PERMIT

SEWAGE DISPOSAL SYSTEM

SUBDIVISION Albeth Heights ROAD Marriottsville Rd. LOT 2, Blk.A

SITE PLAN PROPOSED ADDITION
LOT #2 BLOCK A' SECT. 1
"ALBETH HEIGHTS"
PLAT BOOK 4 PAGE 50

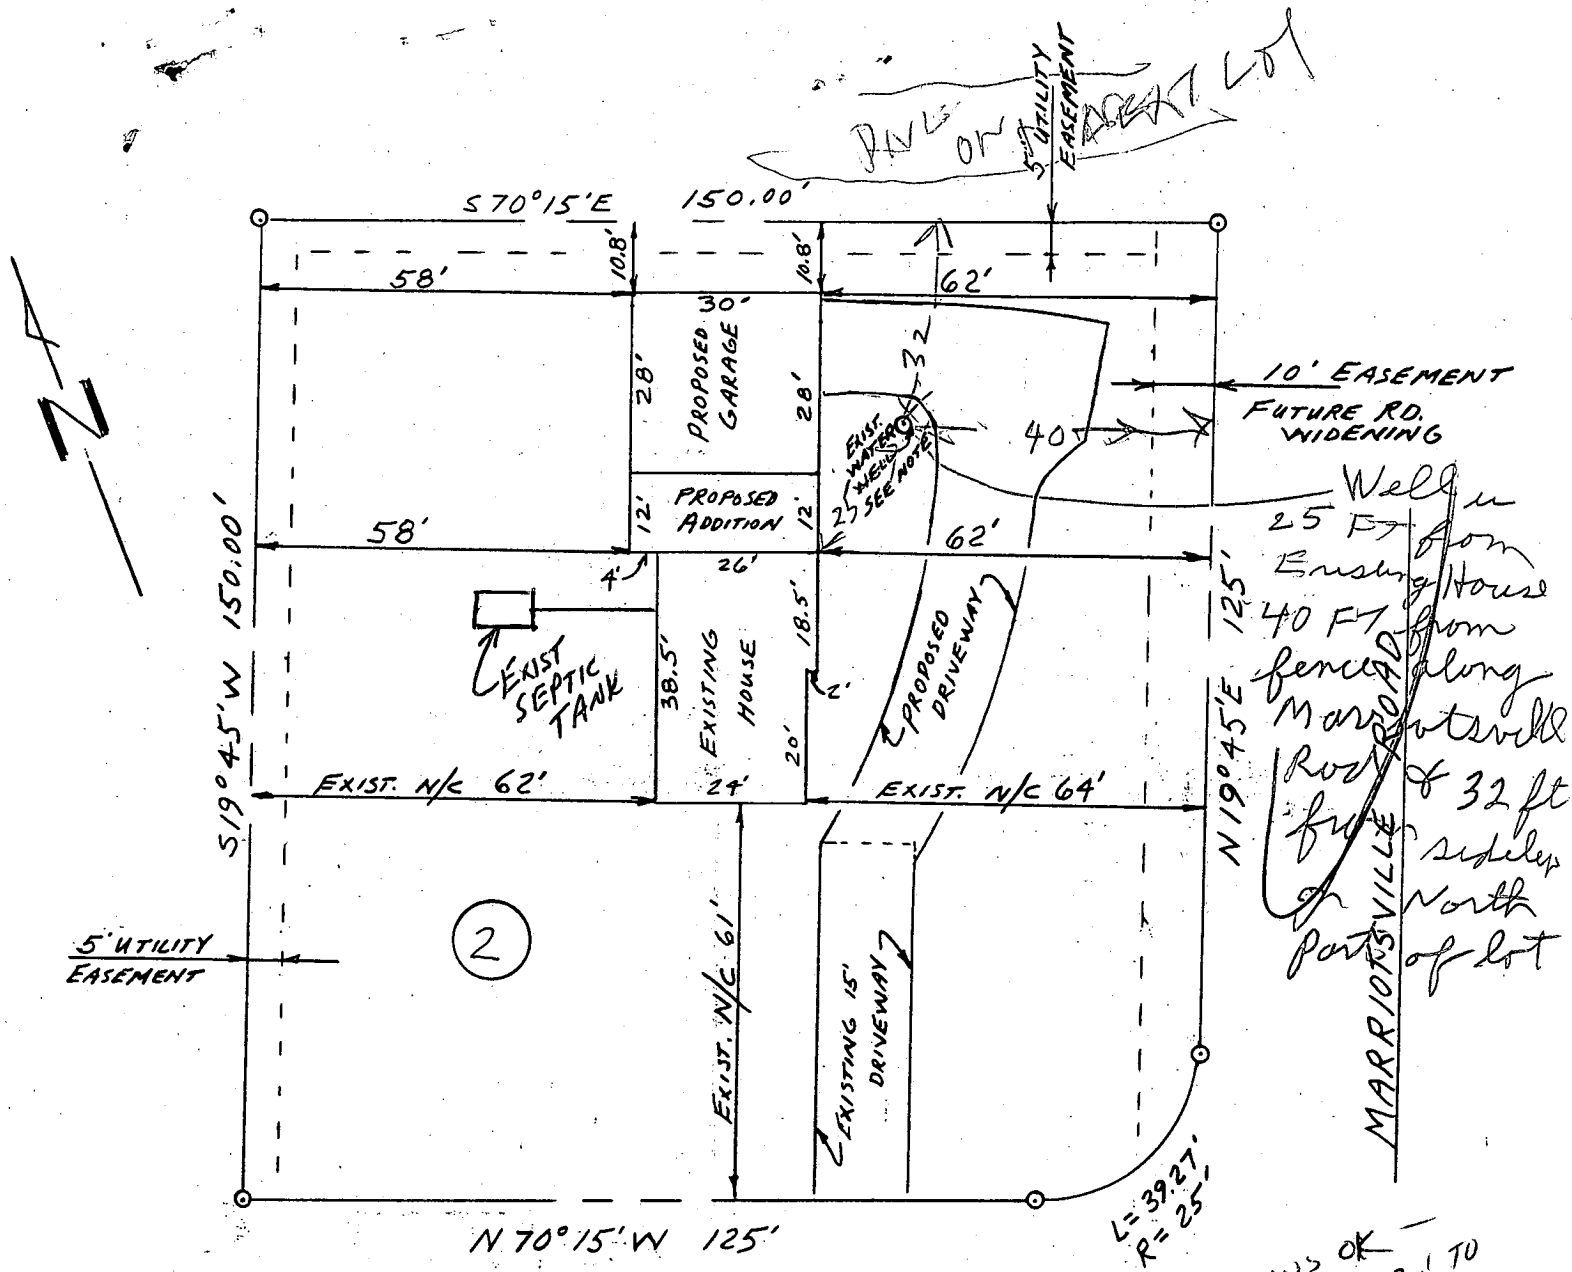
COMMIT
TO TENITE
SHIELDS

SHOW THAT
NO DRIVEWAY
CUT THE WELL

11700' BY PLACEMENT
OF DOOR
GLT
ON BY RAISING
OF DOOR AND
BARRIERS IT

CONDITION OF APPROVAL
BY HEALTH DEPT. 2/20/93

SUBJECT TO
APPLICANT'S COMMIT TO ABOVE

ACCESS IS DENIED TO DRIVEWAY
CROSSING PRIVATE WATER WELL
UNTIL PUBLIC WATER BECOMES
AVAILABLE & PRIVATE SYSTEM
IS ABANDONED.
ALSO NO CHEMICAL PESTICIDE
TREATMENT OF THE PROPOSED
CONSTRUCTION IS ALLOWED

PLANS OK -
LESS THAN 30' TO
WELL, BUT
ADEQUATE PROTECTION
PROVIDED.

PUBLIC WATER
ANTICIPATED
IN A "FEW"
YEARS.

Albeth Heights has been
accepted into the metropolitan
area and will receive water and
sewer within a couple of years.
At the time it becomes
available, I will hook up to
the system.
